Agreement No. CE 15/2000

Study on CAD Standard for Works Departments

Consultation Report (Final Version)

January 2002

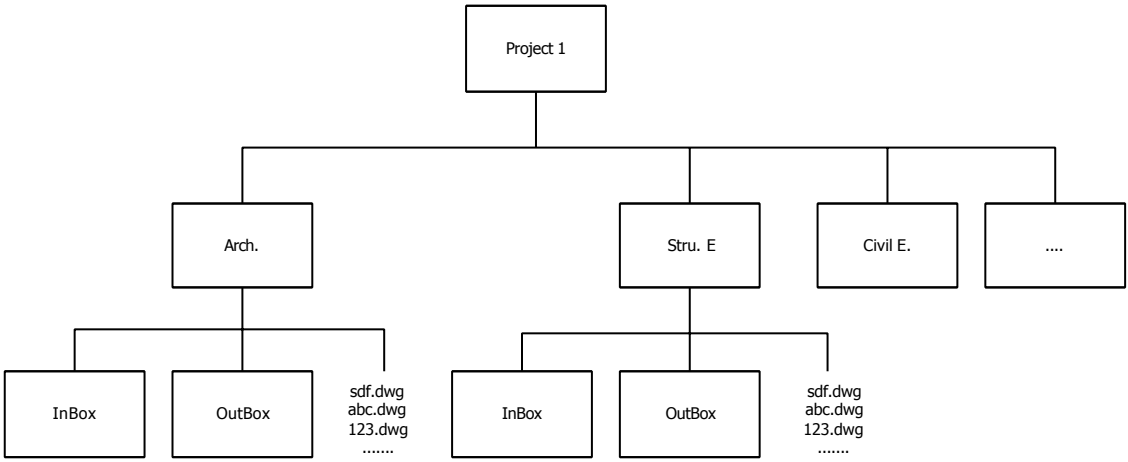
Housing Department, D&C Branch (Alex Ho)	1.4 "Incoming" and "Outgoing" in DMS is shown on the figure below.	Your DMS is obviously well established and, if it works for you, we would not suggest changing it. The structure that you show suits multi-disciplinary working and would enable interface with other parties through the "inbox" directories.
